VSP-37
July 7, 1982

VENDOR SERVICE PUBLICATION

To: All Piper Distributors and CORPAC's
Subject: Bendix Service Bulletins 615, 620, 621

Figure 1

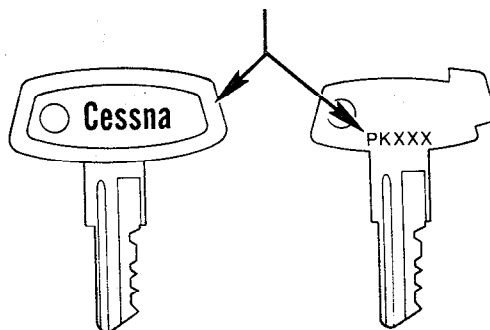
NOTE: The key PK number is located on the key as indicated in figure 1.

Key PK number
stamped in this area.

Have to remove black rubber
from top of key to expose
the PK number.

Figure 1. 10-157197 Distributor Gears with Different Timing Marks

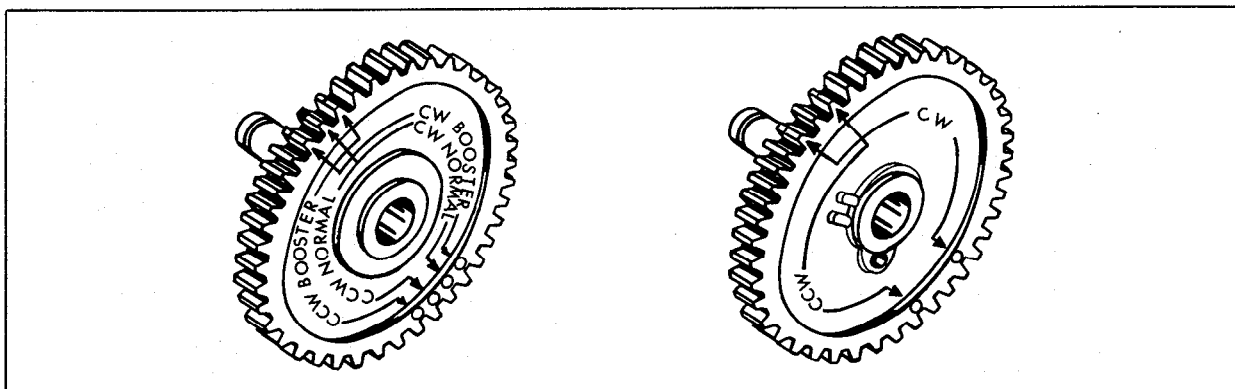
2. If old distributor gear, P/N 10-157197, which incorporated two different molded timing identification marks was used (see figure 1), proceed as follows:

- Remove paint from booster timing positions with suitable solvent.
- Locate normal timing tooth between CW and CCW booster chamfered teeth and paint this tooth and the applicable inner timing mark with red Dykem or red lacquer in accordance with figure 2 or figure 4 for appropriate gear.

Figure 3. Timing Marks on Present Production Distributor Gear Kit Assembly 10-357586

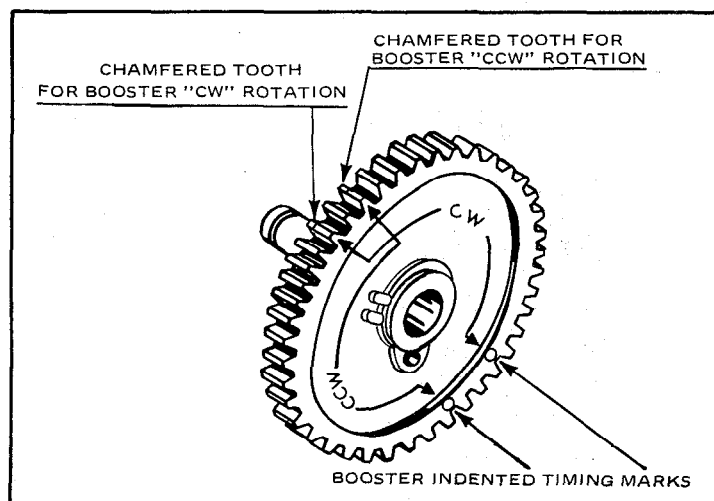
3. If present production distributor gear as supplied in kit P/N 10-357586 is used (see figure 3) proceed as follows:

- Remove paint from booster timing positions with suitable solvent.
- Locate normal timing tooth between CW and CCW booster chamfered teeth and paint this tooth and the applicable inner timing mark with red Dykem or red lacquer in accordance with figure 4.

Figure 4. Present Production Distributor Gear Assembly with Additional Timing Marks Painted

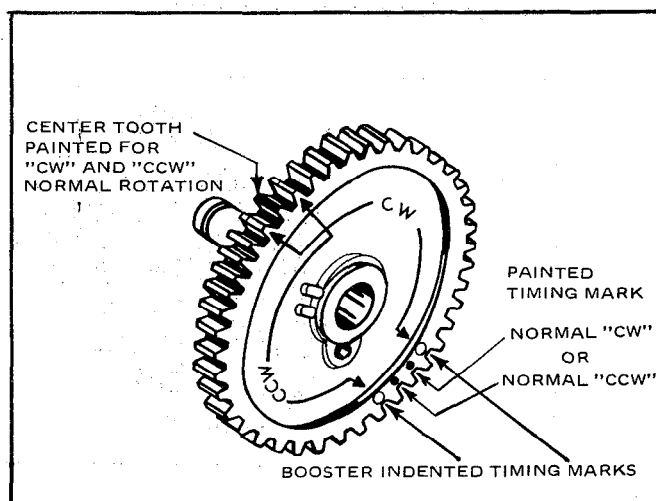
The molded timing marks incorporated in new present production nylon spare part gears, as supplied in kit, P/N 10-357586, are for the booster timing position. Before installation of a new gear kit, the applicable normal timing mark and center tooth must be marked with red

Dykem or red lacquer as illustrated in figure 4.

- Reassemble the magneto using the applicable **normal** timing mark on distributor gear.
- After magneto has been reassembled, identify the magneto by stamping the letter "R" in the upper left hand corner of the identification plate using a 1/16 inch metal stamp.
- Make an appropriate engine Log Book entry indicating that this Service Bulletin has been complied with, recording magneto serial number.

Original Gear Make Up
(Not incorporating insulating or plain steel skid washer.)
Figure 1

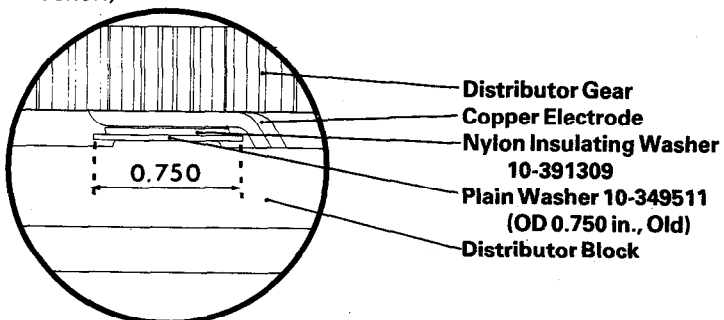
1. Remove the top timing plug.
2. Using a concentrated light beam (a pen light or equivalent) look into the timing hole at the area between the distributor gear and the distributor block parts for existing washer configuration.
3. Current configuration should be as shown in figure 3.
4. Rework magneto whenever configuration is as shown in figure 2.
5. An acceptable configuration is shown in figure 1.

Insulated Gear Configuration
(Incorporating 10-357586 Kit parts with *incorrect* washer.)
Figure 2

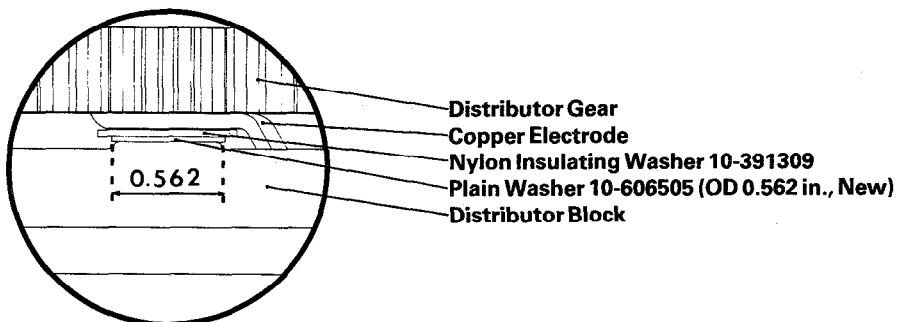
It has been determined that plain steel washer P/N 10-349511 installed on the gear axle between the nylon insulating washer P/N 10-391309 and the distributor block bronze oil-lite bushing (see figure 2) can cause electrical flash-over in the distributor at altitude. Inspect for compliance as follows:

1. Remove magneto from engine.
2. Disassemble as required using procedures described in Bendix Overhaul Manual Form No. L-205-10 for S-20 and L-527-4 for S-200 series magnetos.
3. Remove retaining ring and plain washer. Discard retaining ring. Remove distributor gear from the distributor block.
4. Inspect the distributor block for burning or carbon tracking and serviceability. Replace if defective.
5. Remove old plain steel washer P/N 10-349511 (OD 0.750 in.) and nylon insulating washer P/N 10-391309 from the gear axle.
6. Reinstall nylon insulating washer P/N 10-391309 and install new plain washer P/N 10-606505 (OD 0.562 in.) on gear axle. See figure 4 for assembly order.
7. Wipe distributor gear axle clean, then reinstall it in the block. Place plain washer P/N 10-349511

on axle shaft and secure with new retaining ring P/N 10-92815-37.
